Project 71235.01
21 Feb 2011
TJW:III

**Placement of Scour Protection Blanket over Soft Sediments
Inner West Marina, Breakfast Point, Sydney**

Figure 1: Stability of Reclaimed Sand Slope on Very Soft Sediments

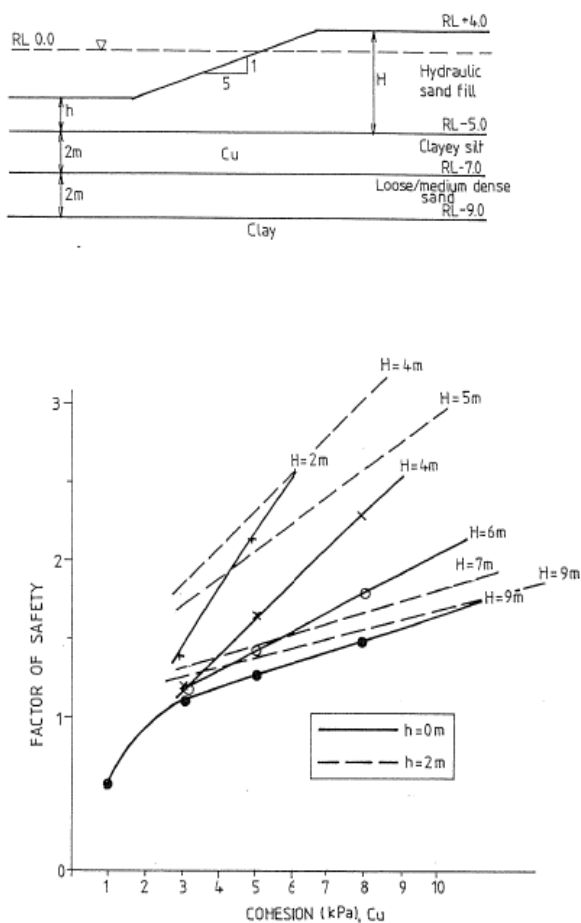
This may be true but requires strength values for the clays and accurate modelling of sub-seabed stratification to analyse reliably. Figure 1 indicates shear strengths required for stability of a sand batter of 1V:5H. The batter of the blanket has a greater impact on the stability of the edge slope of the capping than the bottom slope provided the bottom slope is less than 1V:15H.

The bed of Kendal Bay slopes at shallow angles of 1:25 (V:H) or flatter. Placement of the rock capping layer will need to be controlled so uncontrollable spreading does not occur. Edge batter slope will depend on sediment shear strength with the stable edge batter likely to be closer to 1V:5H than 1V:1.5H.

Figure 2: Settlement v Time of Different Thicknesses of Soft Clay under 100kPa

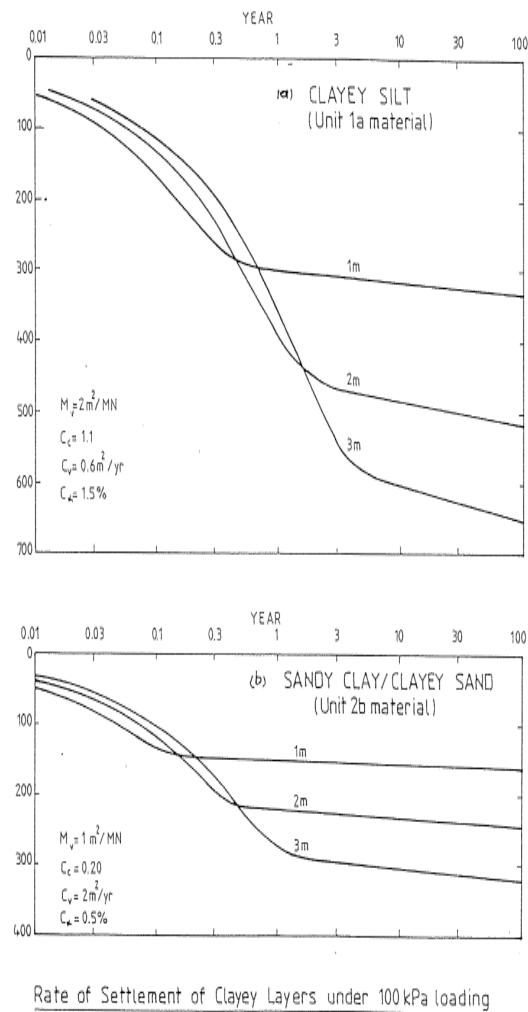
Figure 2, also from the Parallel Runway Project shows typical settlement versus time flats for 1, 2 and 3 m thickness of clayey silt and sandy clay materials under 100 kPa loading. Settlement under 10 kPa would be one tenth of 100 kPa, and so on. The clayey silt material is probably similar to the sediments at Breakfast Point.

Figure 3: Conceptual Model

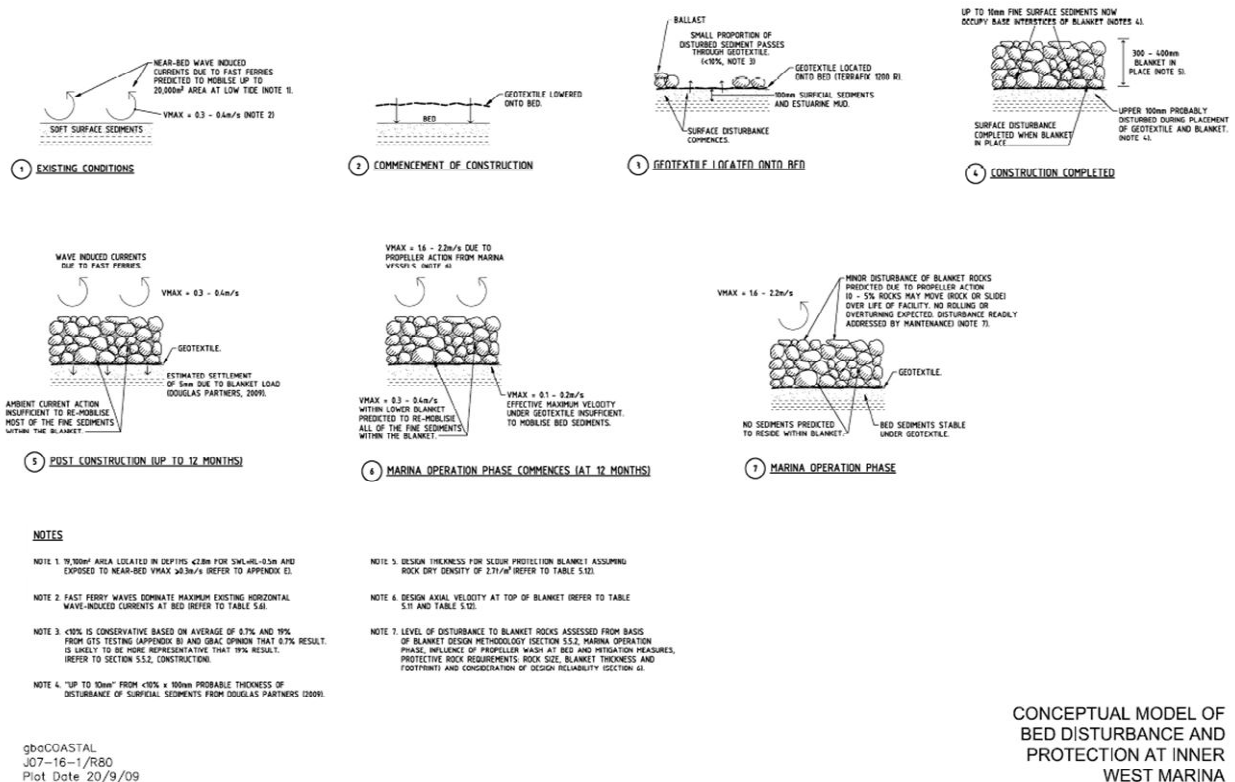
1	Existing conditions	Near-bed wave-induced currents due to fast ferries disturb large areas within Kendall Bay including the proposed marina footprint area.	The number of ferry journeys does not reduce when the marina is in place, the route taken simply changes. The sediment disturbed is less however, the increased traffic from the marina probably equals the difference. Therefore the same amount of contaminated sediment will still be disturbed, just in a different location.
---	---------------------	---	---

2	Commencement of construction	Geotextile forming part of the blanket is lowered onto the bed.	This will not be straight forward. This geotextile is spun bound and 5.7mm thick. A significant amount of air is trapped within the geotextile which will mean it will want to float. It will not simply fall onto the bed. Current velocities will make handling difficult. There is no evidence presented to show there are no obstructions on the bed and how they will be
---	------------------------------	---	---

dealt with and the resulting sediment disturbance.
3	Geotextile located onto bed	The geotextile comes to rest on the bed and ballast is placed to temporarily secure the geotextile placement. In the process of coming into contact with the bed and being located to its correct position, disturbance of surface sediments commences. Upper 100 mm of bed sediments probably affected during construction of the blanket (<i>Douglas Partners, 2009</i>). Small proportion of the disturbed sediment passes through the geotextile (<i><10% of upper 100 mm over the duration of blanket construction</i>)	Because the sediment is normally consolidated and underconsolidated in nature, the temporary ballast will cause local bearing capacity failures and disruption to the blanket. There has been no justification of the 100mm of disturbance; it is likely to be significantly greater. The hydrodynamic testing shows significantly greater amounts of sediment passes through the geotextile than the assumed 10%. There has been no justification of the 10mm used.

4	Construction completed	300 – 400 mm thick layer of rocks comprising the upper blanket is placed. Disturbance of surface sediments is complete when construction of the blanket is completed. Up to 10 mm of fine surface sediments now occupies the base interstices of the blanket.	Because of the very soft nature of the contaminated sediments, placing the rocks without causing significant localised displacement of the sediment will be very difficult. As a result the effective depth of the blanket in places could be as little as 100mm. See comments in 1 above regarding the sediment in the base of interstices of the blanket.
---	------------------------	---	---

5	Post construction (up to 12 months)	Ambient currents, including the controlling wave-induced currents due to fast ferries, are insufficient to remobilise most of the 10 mm of fine sediments within the rock blanket.	Some of the sediments will be remobilised because there will be more than the 100mm present (see comments to 1 above). Because there will not be an effective cover of 300 to 400mm the wave reduced currents will disturb the sediments.
---	-------------------------------------	--	--

6	Marina operation phase commences (at 12 months)	Once vessels take up their berths within the marina, their propeller action is predicted to remobilise all of the 10 mm of fine sediments located within the rock blanket.	It is agreed that the vessels will remobilise all the sediment located in the rock blanket. Therefore, a significant larger amount of
		This material is suspended into the water column, and dispersed elsewhere within Kendall Bay and beyond, under the action of ambient currents. Tidal flows and wind induced currents would be expected to dominate the dispersion process. The blanket geotextile itself reduces the penetration of ambient currents to the underlying bed sediments such that the velocities under the geotextile are insufficient to mobilize these sediments.	sediment will be redistributed elsewhere in Kendall Bay than calculated by the proponent as explained above. Because the effective thickness of the blanket may sometimes be less than the design thickness the ambient currents in the underlying bed sediments will be sufficient to mobilize the sediments.

7	Marina operation phase	During operation, minor disturbance of blanket rocks is predicted due to propeller action of vessels located within the marina. Based on the adopted blanket design methods, it is predicted that 0 – 5% of the rocks within the blanket may move over the life of the facility. This disturbance of the blanket rocks is readily addressed by routine maintenance. Any minor mobilisation of the blanket rocks during marina operation and any required maintenance would not be expected to disturb the bed of Kendall Bay under the blanket such that further sediment loss up through the blanket could occur.	Recontamination of the blanket from the far field disturbance has been ignored. Significant amounts of sediment will settle on the blanket which in turn will be remobilised by the vessels using the marina. In turn these will be remobilised to other parts of Kendall Bay. When this continued sediment disturbance is added to the continued disturbance by the fast ferries (and probably increased ferry numbers due to the Sydney Ferries identification of Cabarita wharf demand) and the increased pleasure craft, the total disturbance to sediment will remain unchanged to that which currently occurs.

Water traffic is impossible to reliably predict, however the scour protection blanket will greatly reduce or even possibly eliminate the extent of sediment disturbance from water traffic. So the last statement under 1. is incorrect.

Agree placement of other than a coarse open geotextile (a geogrid) will be difficult. Is a geotextile necessary? Other than as a marker layer in which case a geogrid could be suitable. Further contamination testing of the seabed may show that recent sediments on the seabed are not contaminated as it did at Sydney Airport. Consideration could also be given to placing a sand layer over the geotextile or directly over the soft sediments.

The 100 mm of disturbed sediments is an initial estimate, probably an overestimate. The depth of disturbance could be much less depending on placement technique and sediment shear strength. Placement of the rock fill on top of the geotextile needs to be trialled initially to develop appropriate techniques then monitored during placement over the whole area. The strength of the clays is an important factor affecting the extent of disturbance as is the rock size. It may be necessary to place an initial layer of sand or finer gravel to cushion the placement of the rock layer.

A sand layer may address this concern if a trial indicates problems with rocks.

This is speculation and depends on the grading and sizes of the rock and success of placement. If the capping layer is well graded and the sediments relatively undisturbed then currents will not affect the small amount of sediment that is in the seabed.

Previous comment also applies.

If the capping is successfully installed so as to prevent disturbance of sediment then this comment does not apply.
